Mamre Road upgrade between the M4 Motorway and Erskine Park Road

Addendum review of environmental
factors
April 2024

This document is an addendum Review of Environmental Factors (Addendum REF) for a proposed modification to the approved 'Mamre Road upgrade between the M4 Motorway and Erskine Park Road' project (the approved project).

Figure 1-2: The proposed modification

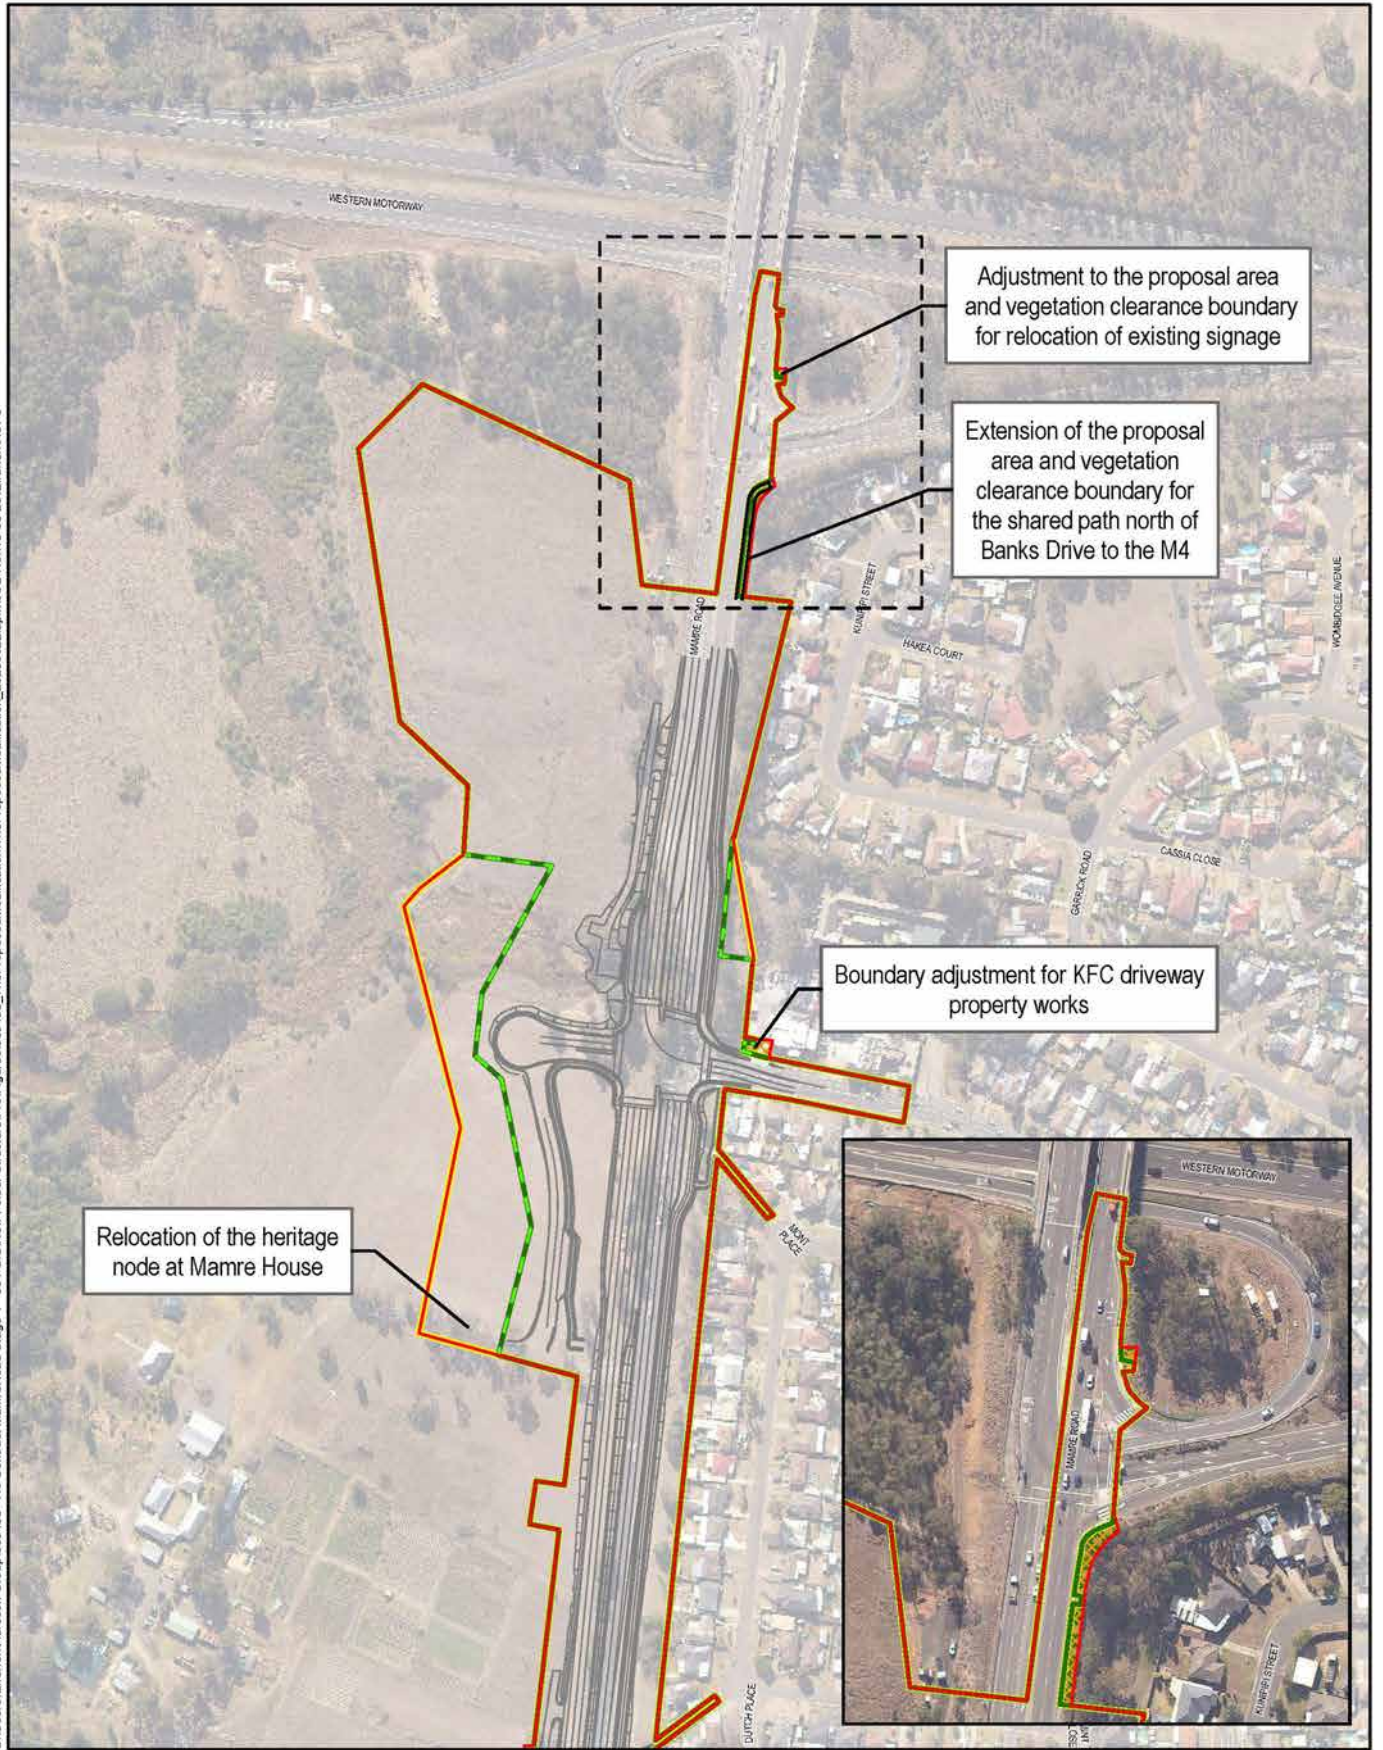
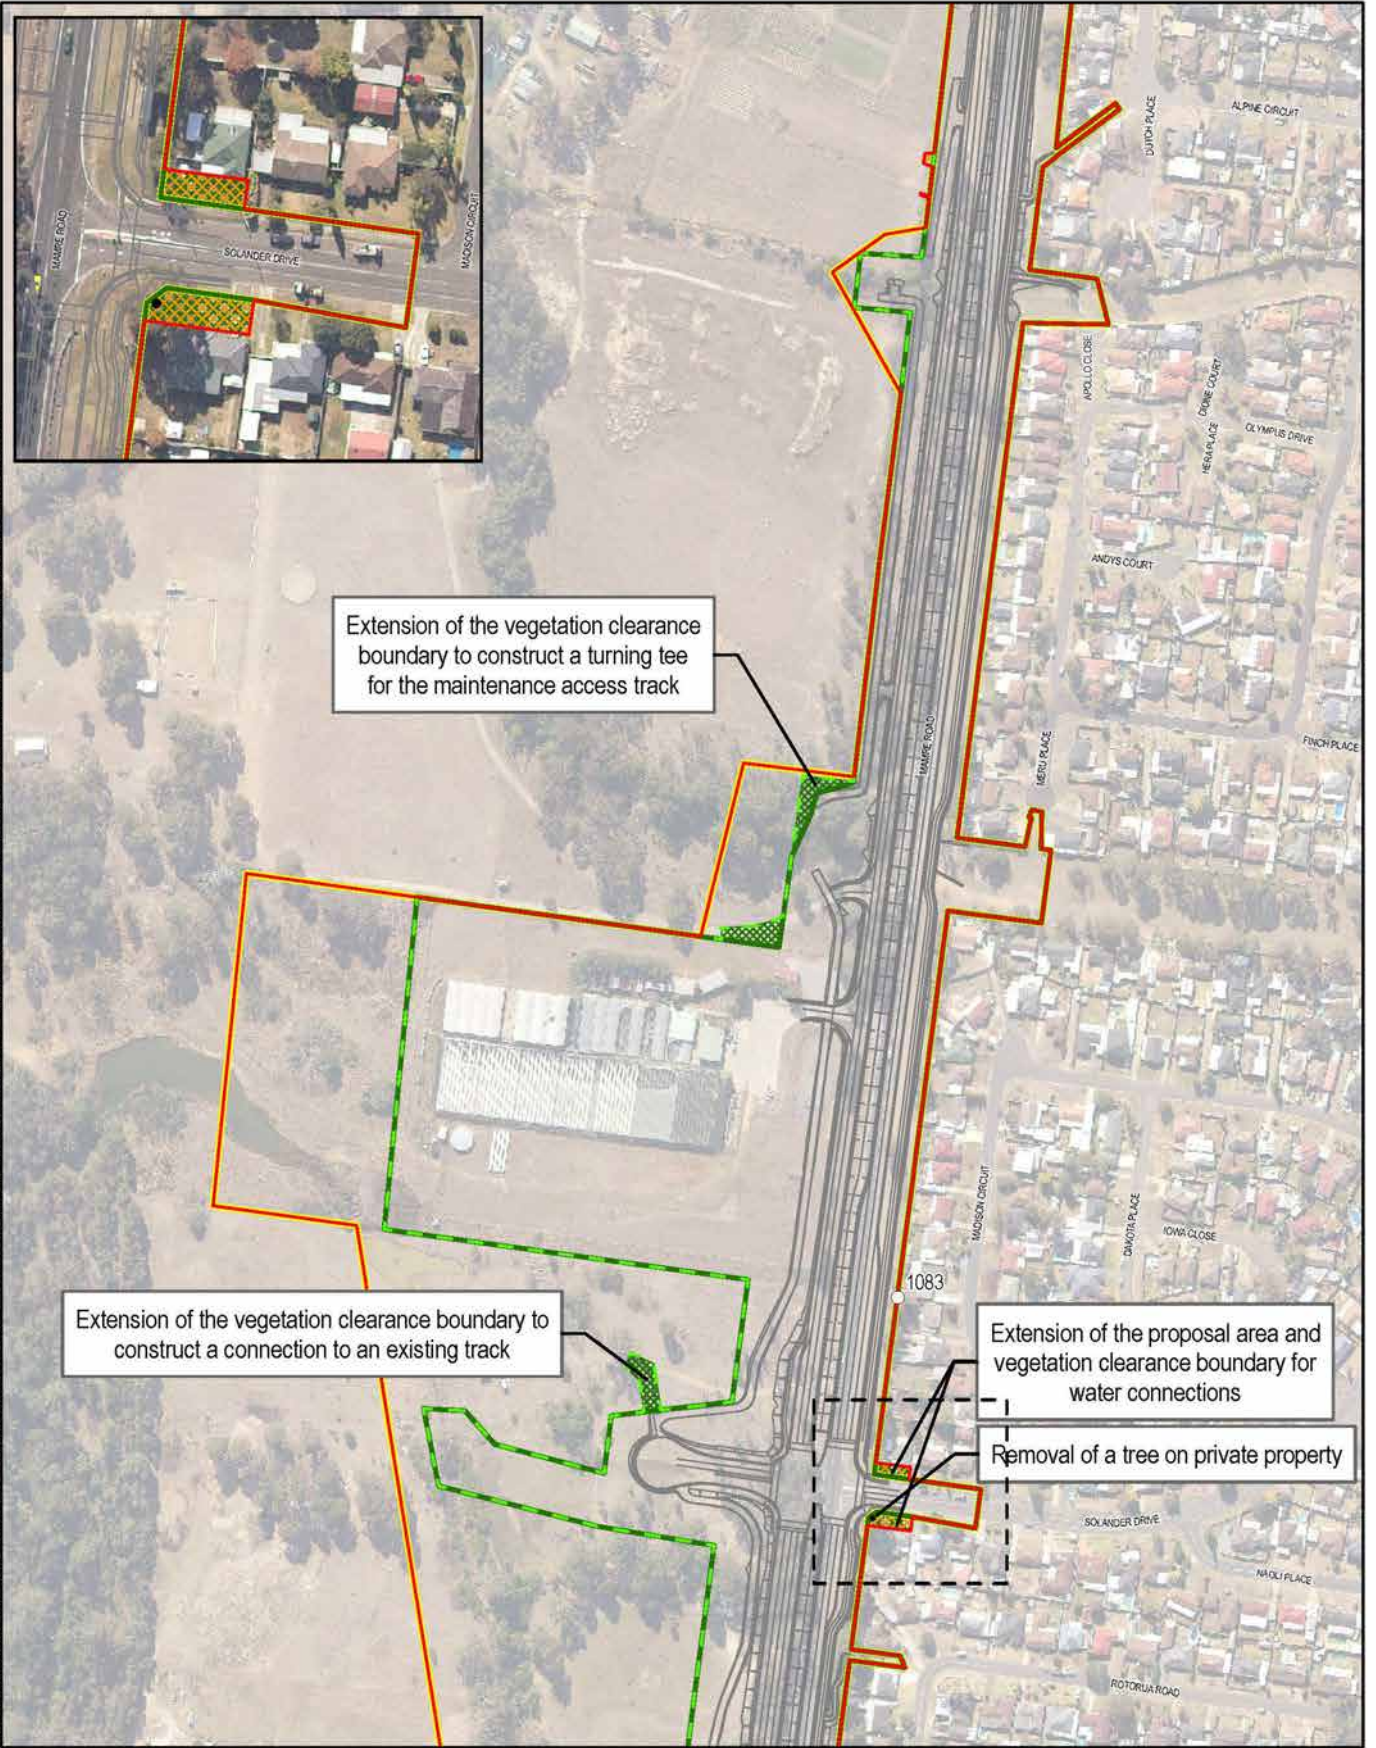
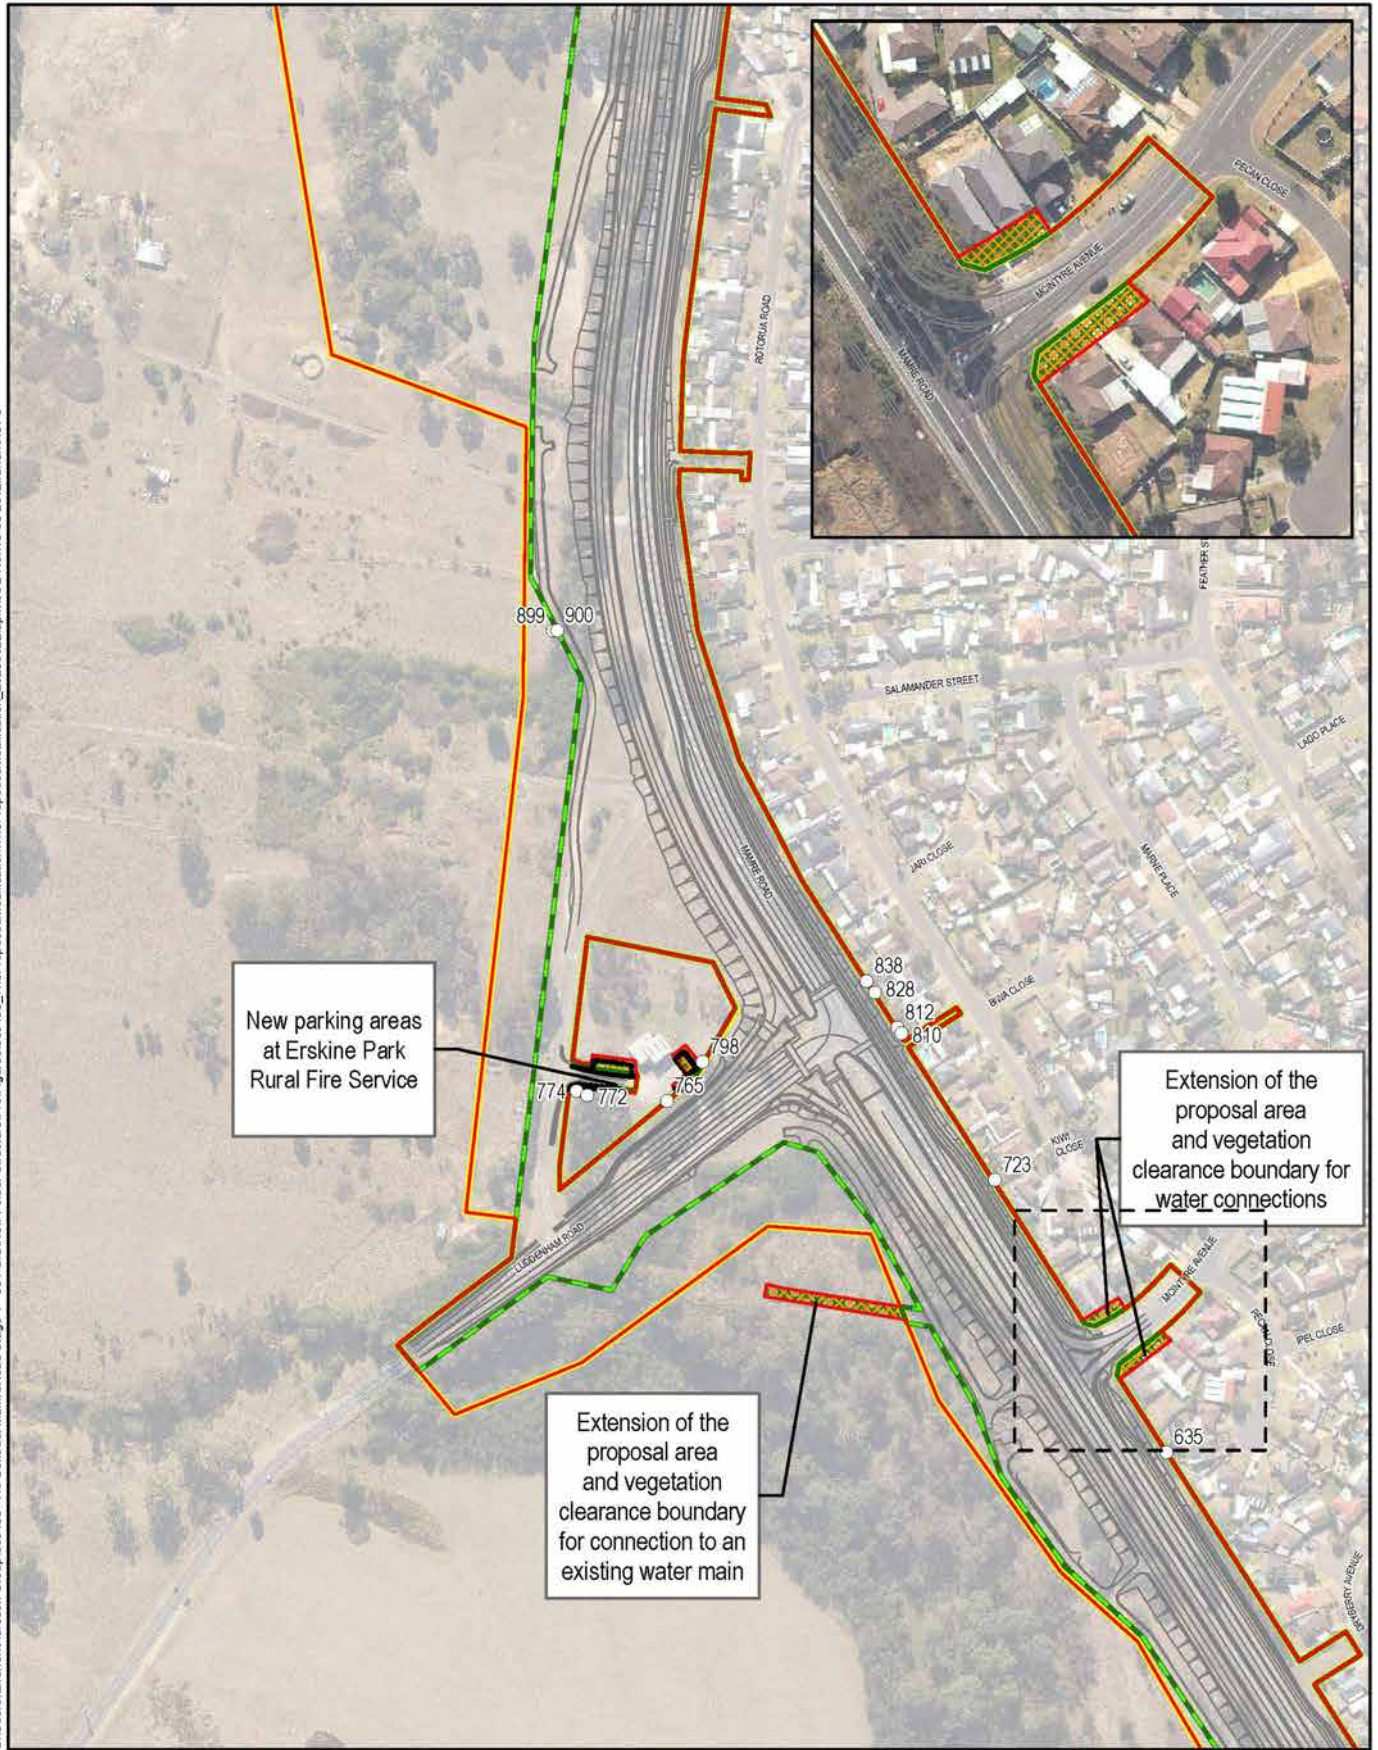
Transport now proposes to modify the approved project to facilitate adjustments to utilities, minor property work and other minor work to support the upgrade of Mamre Road (referred to as the proposed modification). Key features of the proposed modification include:

- basin filling work and refinements to drainage channels
- property work including the relocation of parking areas at Erskine Park Rural Fire Service, adjustment to the driveway at the KFC fast food restaurant, and relocation of an existing earth mound within private property

- removal of additional trees identified by an arborist to have likely root impacts from the road upgrade work (see Figure 1-2)
- extension of the shared path between Banks Drive and the M4 Motorway

- relocation of the heritage node near Mamre House
- provision of additional space to enable fence construction (see Figure 1-2)
- construction of a turning tee to connect to an existing access track located on the western side of Mamre Road (see Figure 1-2)

- relocation of existing signage near the northern extent of the approved proposal area to an existing post
- utilities that may require additional excavation outside of the approved proposal area.
